8.0 RESPONSES to COMMENTS on the RECIRCULATED DRAFT EIR

This section includes the written comments received during recirculation of the Draft Environmental Impact Report (“Recirculated Draft EIR”) prepared for the 8555 Santa Monica Boulevard Mixed-use Project and responses to those comments.

²⁴ Planning Commission meeting 7 March 2019, Exhibit K project plans, “Mezzanine Floor Plan,” page 24.

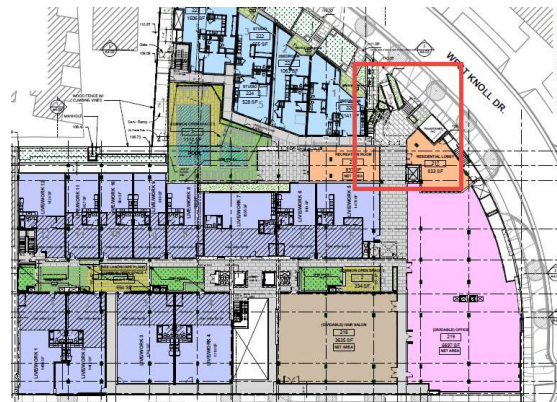
²³ The portion of the carriage lane between the driveway and the corner at Santa Monica Blvd would be for loading, unloading and idling so that right-turn traffic onto Santa Monica Blvd would not be impeded. The portion of the carriage lane to the north of the driveway apron would be a yellow loading zone for any moving vans and car service so traffic on West Knoll Dr is not impeded.

serve to move project traffic off the street and onto project property. This is a standard convention for large multi-unit residential buildings.
